<b>Docket Number:</b>	06-AFC-09C
<b>Project Title:</b>	Colusa Generating Station - Compliance
<b>TN #:</b>	203611
<b>Document Title:</b>	Application for Staff Approved Project Change to Amend Docket - Steam Turbine Deck Grating
<b>Description:</b>	N/A
<b>Filer:</b>	Charles Robert Price
<b>Organization:</b>	Pacific Gas & Electric Co.
<b>Submitter Role:</b>	Applicant
<b>Submission Date:</b>	2/6/2015 9:21:26 AM
<b>Docketed Date:</b>	2/6/2015

**Subject: Petition To Amend The Commission Decision For The Colusa Generating Station.**

## **COLUSA GENERATING STATION APPLICATION FOR STAFF APPROVED PROJECT CHANGE**

ST/G AREA UTILITY BRIDGE  
GRATING & GUARDRAIL PIPE OPENINGS &  
SUPPORT STEEL EL 142'-0" & 151'-2"

**Gamma**  
Gemma Power Systems California, Inc.

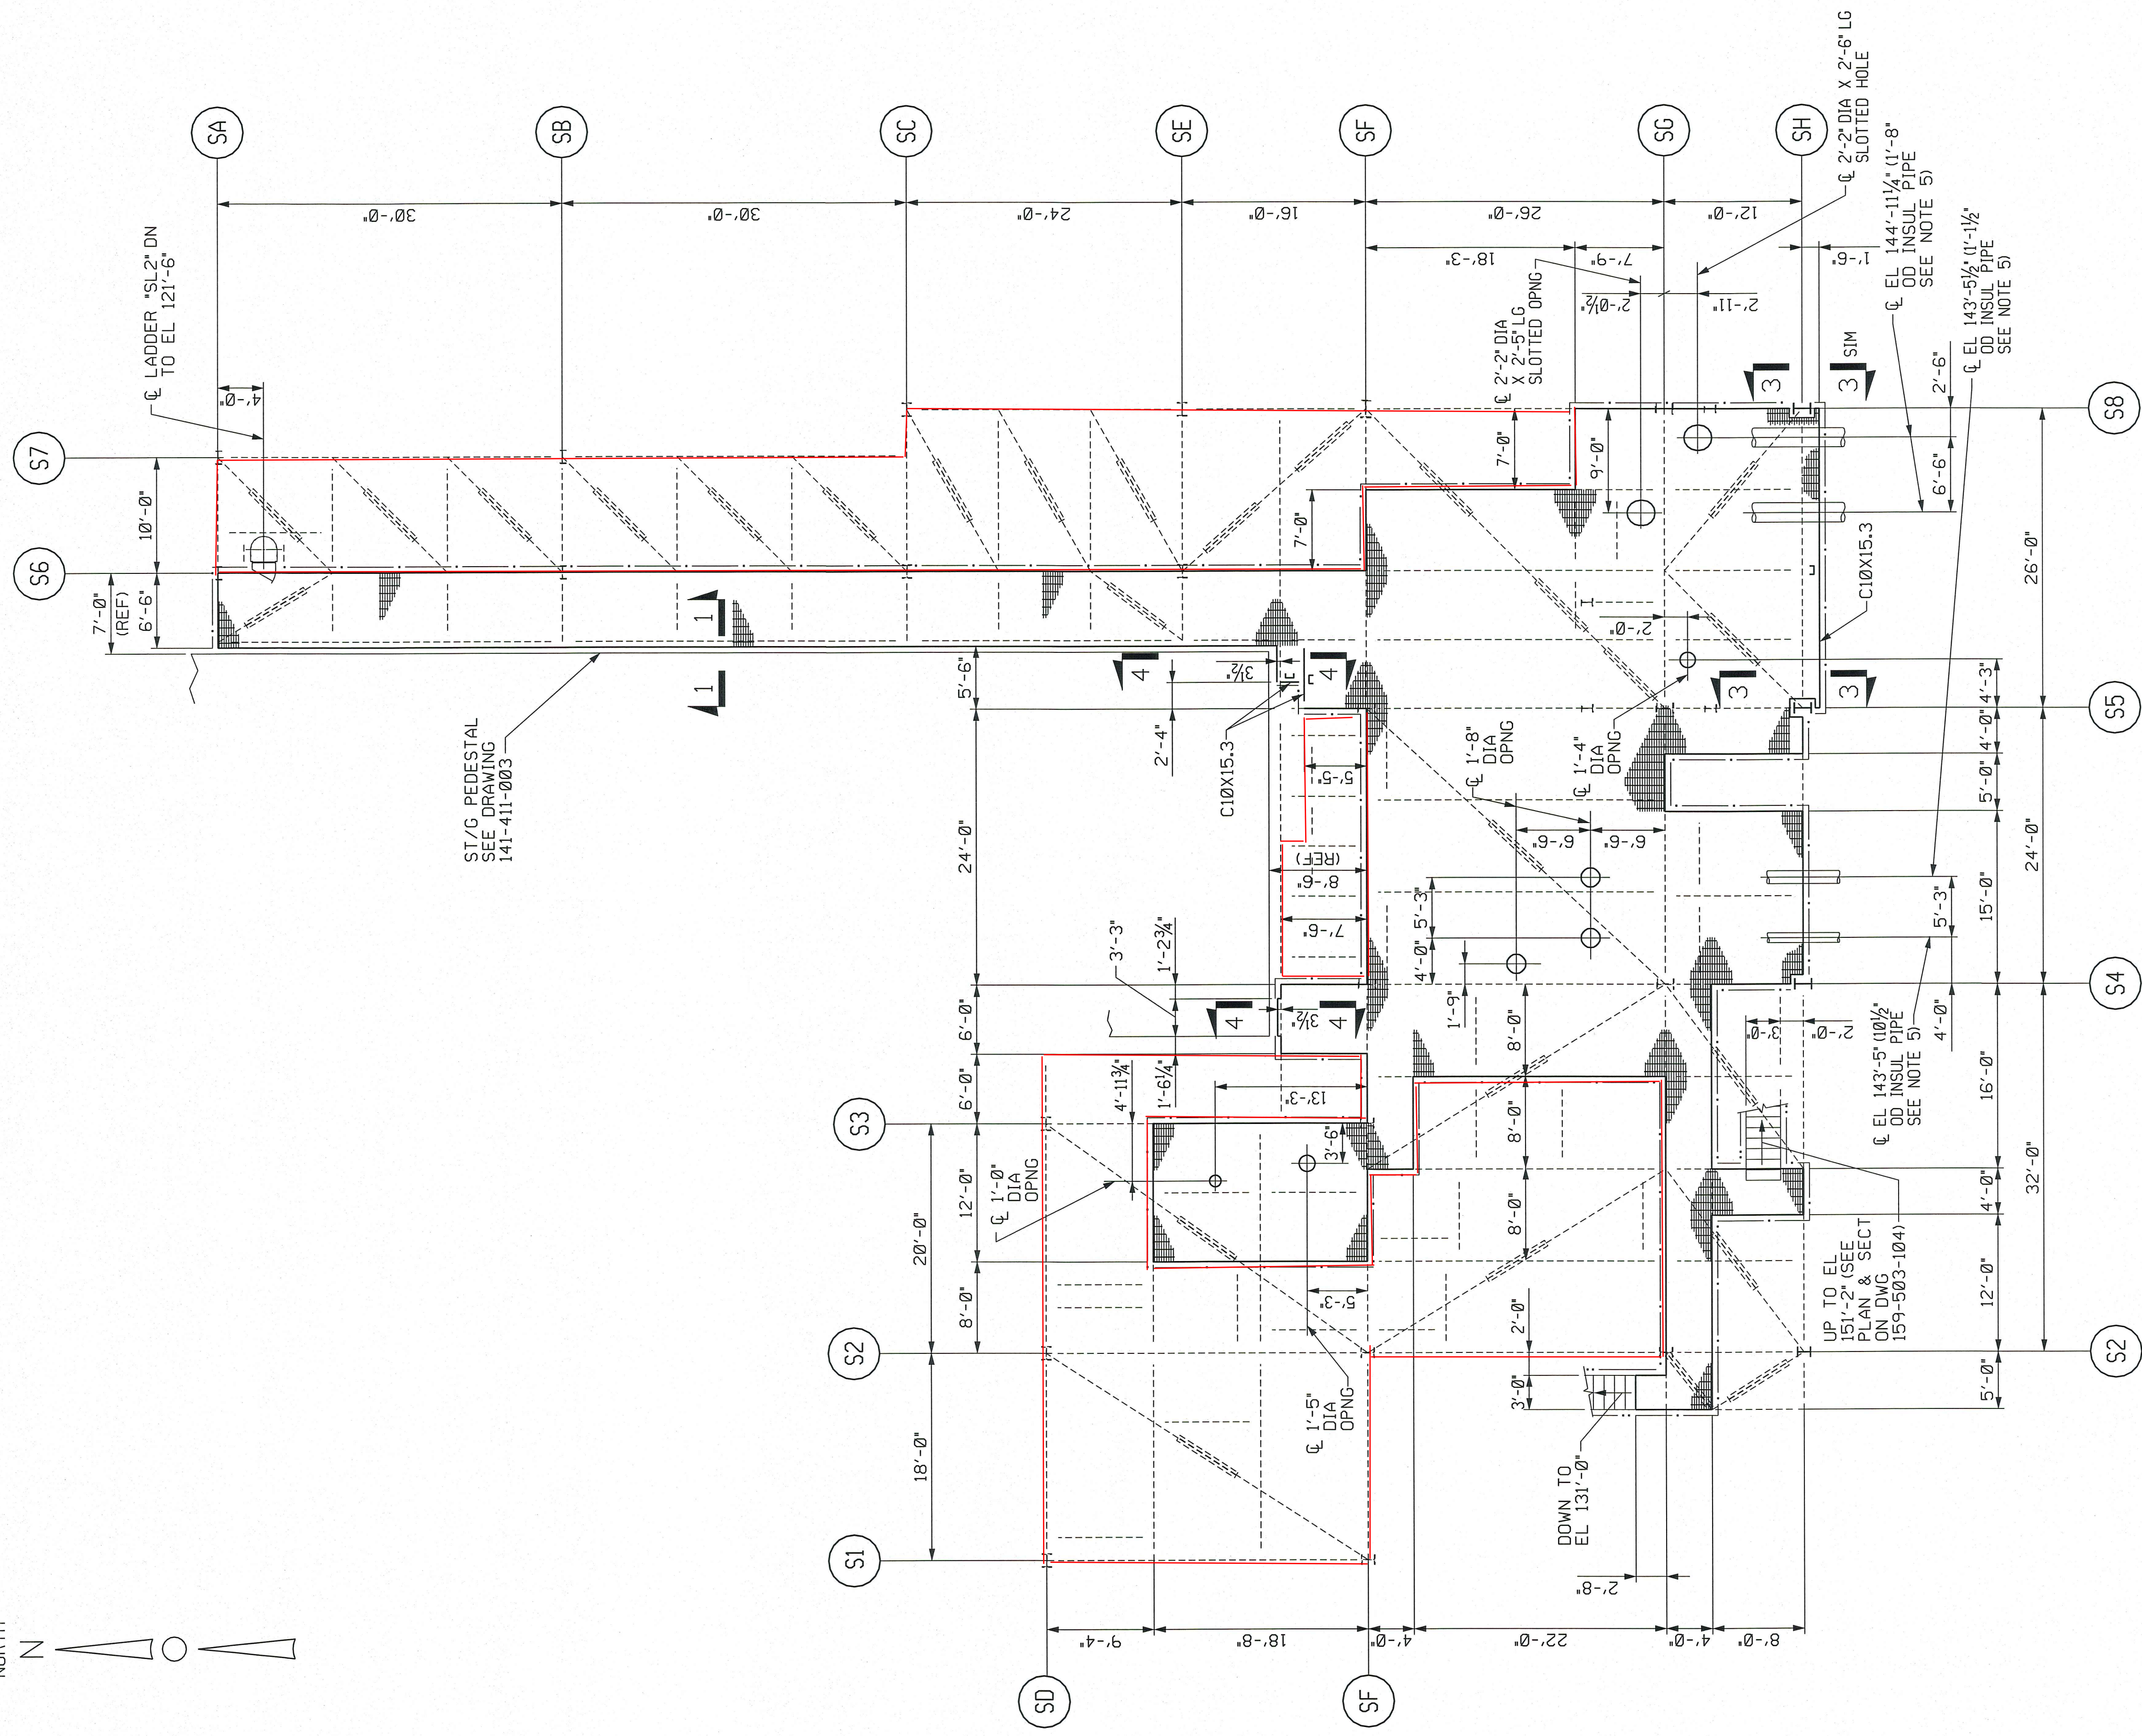
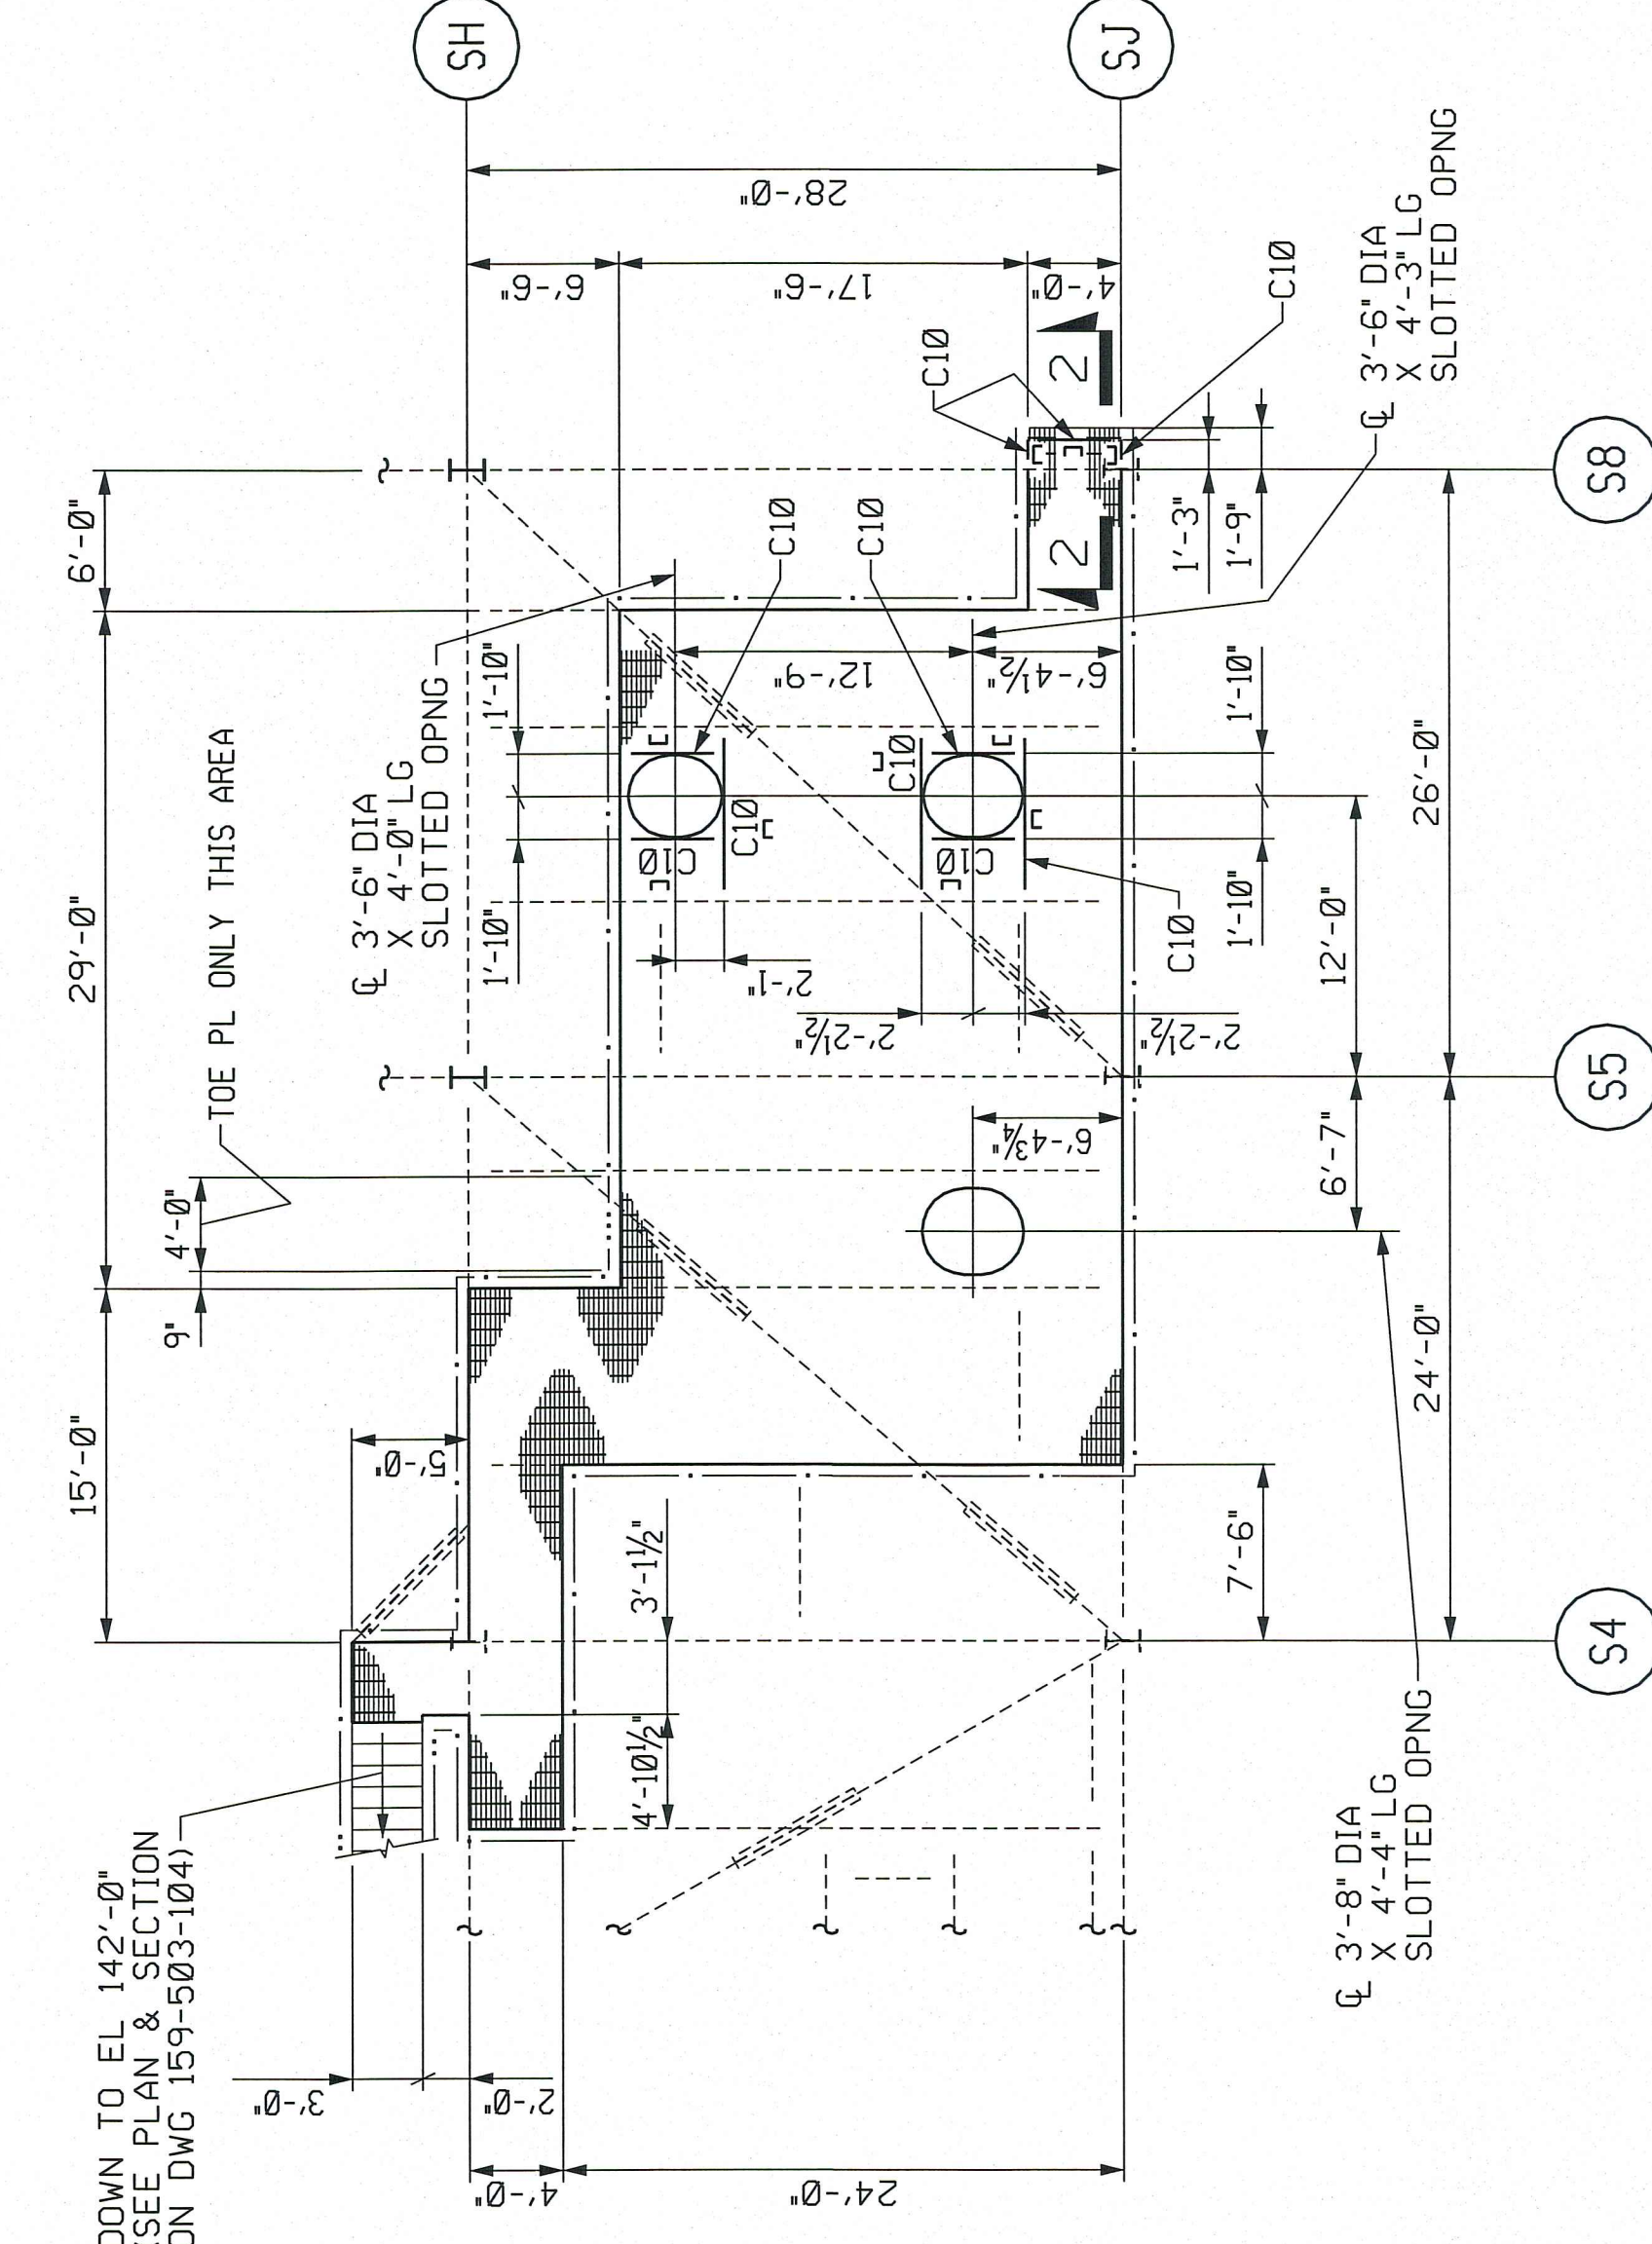
The CGS plans to install additional grating on the Steam Turbine deck to increase the useful area of the workspace.

This grating will allow crews working on the Steam Turbine or its associated Generator to work more safely and efficiently by creating more work space. Currently a limited amount of tools and equipment can be stored on the deck during maintenance resulting in unnecessary trips up the stairs for crew along with a greater amount of crane hoists required.
